# SUZUKI 2-Stroke Service Bulletin

Subject: INSTRUCTIONS FOR USING GT380/550/  
750 CARBURETOR SYNCHRONIZATION TOOL

Bulletin No: GT-22  
Date: May 1, 1975  
Read and Initial \_\_\_\_\_  
Manager \_\_\_\_\_  
Parts \_\_\_\_\_  
Service APP

Subject: GT550 STARTER CLUTCH CHANGENOTICE:

WIRING HARNESS NO. 1

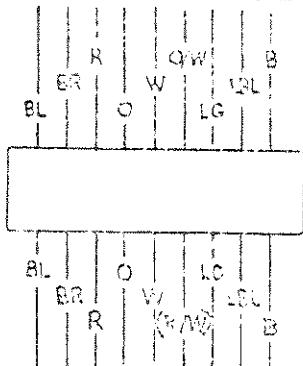
Listed below are the basic color code changes which have been necessary. Variations of the color codes listed below may occur, while some units may be equipped with the standard color codes.

( ): INDICATES THE  
SUBSTITUTE COLORS

WIRING HARNESS NO. 1

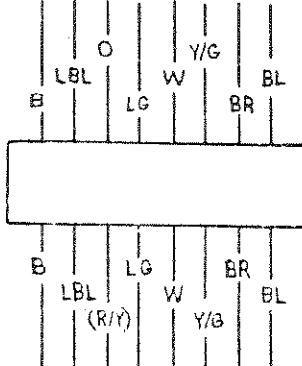
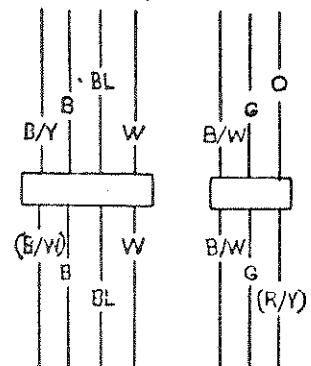
( ): INDICATES THE  
SUBSTITUTE  
COLORS

OLD TYPE (3-roller)NEW TYPE ("Borg Warner")INTERCHANGEABILITY:

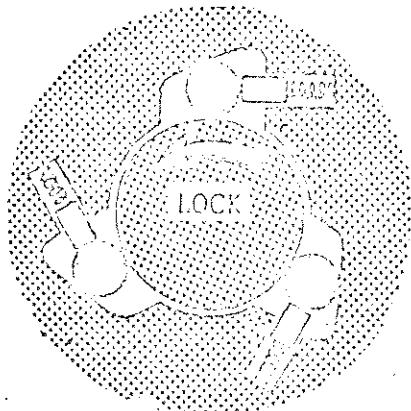
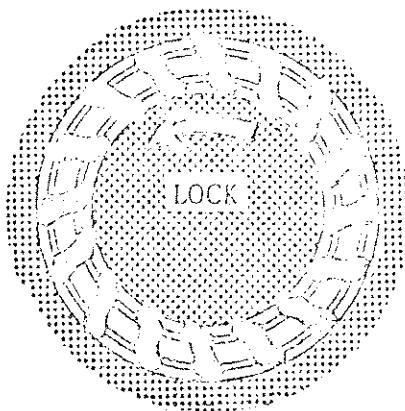
To increase the durability of the GT550 starter clutch assembly, its design has been changed from a 3-roller to a "Borg Warner" type clutch.

The old and new type starter clutches are interchangeable as an assembly only. Individual components are not interchangeable.

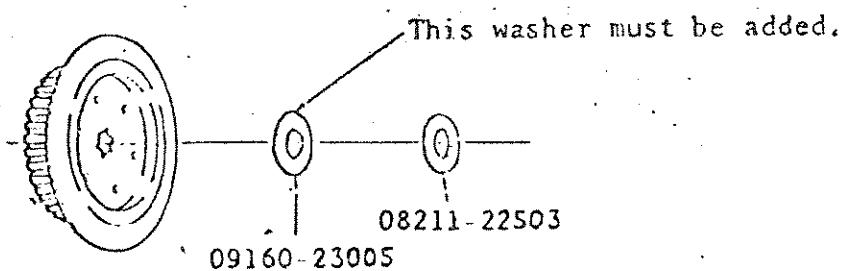
Changes to the individual component parts are explained below:

\*The new style clutch sleeve hub, either the flat or hollowed out type as shown above, can be used with the old style primary driven gear, as long as a 3mm washer (09160-23005) is used between the standard thrust washer and hub as shown below.

### Needle Bearing:

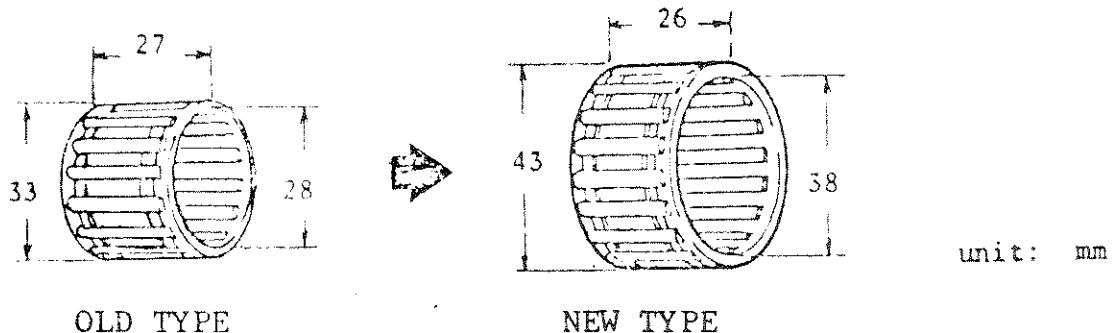
The dimensions of the needle bearing have been changed as shown.

Two needle bearings are used in the new type starter clutch assembly; one for the primary driven gear and one for the starter clutch gear.

### Primary Driven Gear Spacer:

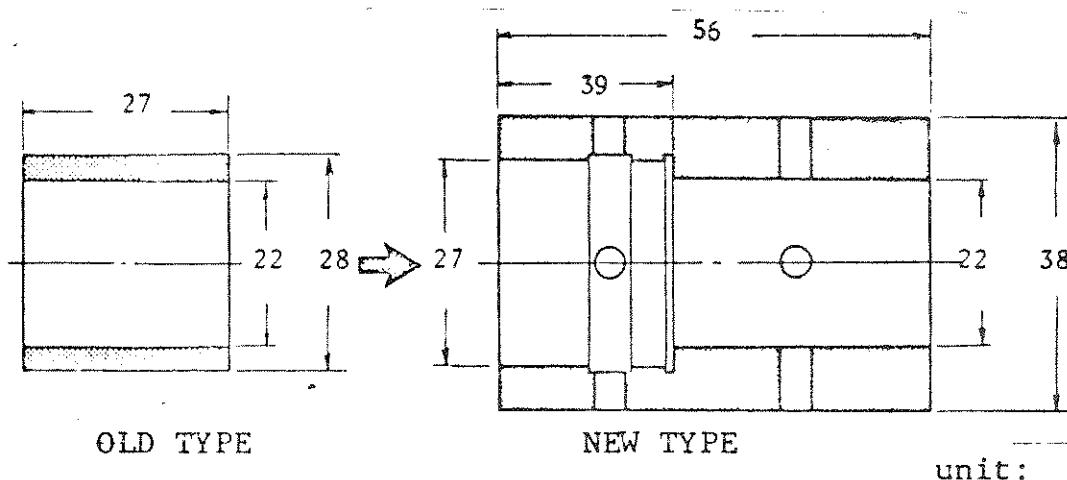
The dimensions and shape of the primary driven gear spacer have been changed as shown.

Primary Driven Gear Assembly:

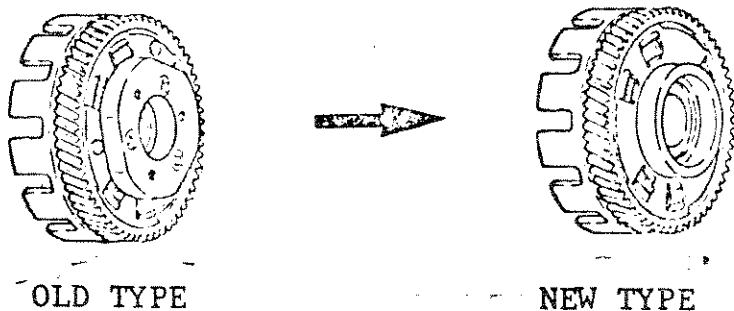
The primary driven gear assembly has been changed to incorporate the new one-way starter clutch.

Starter Clutch Gear:

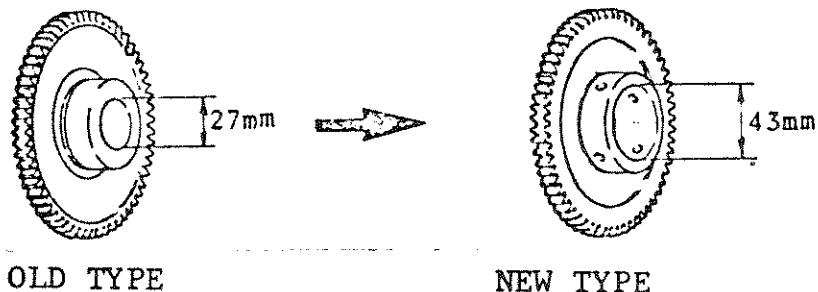
The shape and inside diameter of the starter clutch gear has been changed as shown.
